Mobile de GMT / GMT-Rad / GMT wheel

SW330-2

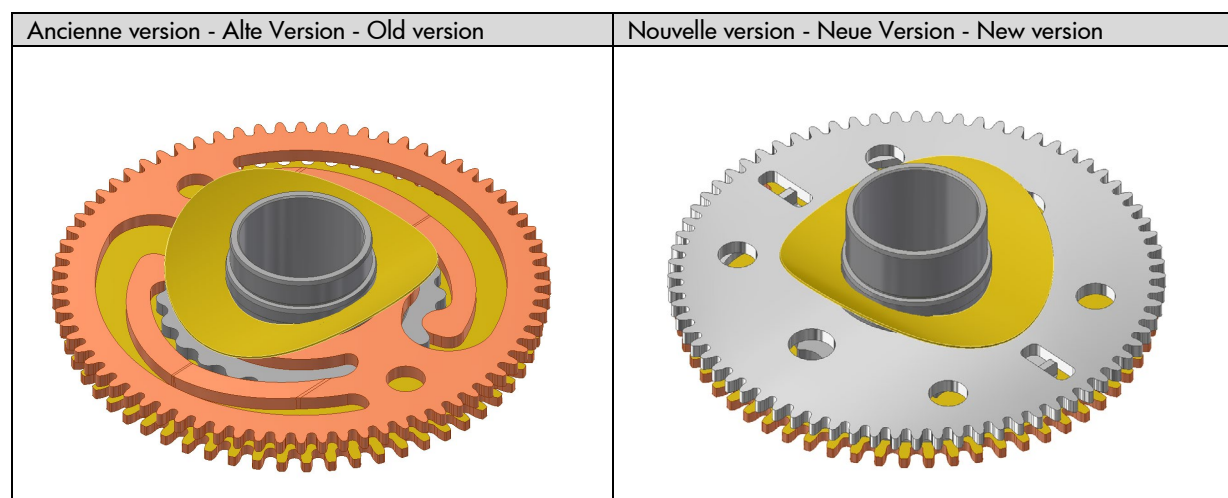
As part of the continuous improvement of our products, we have developed a new GMT wheel that provides a sharper, more precisely defined jump, resulting in a more positive and distinct feel during correction.

The reinforced design of the upper wheel also reduces its wobble, improving its axial runout and overall stability.

Both versions of the GMT wheel are interchangeable.
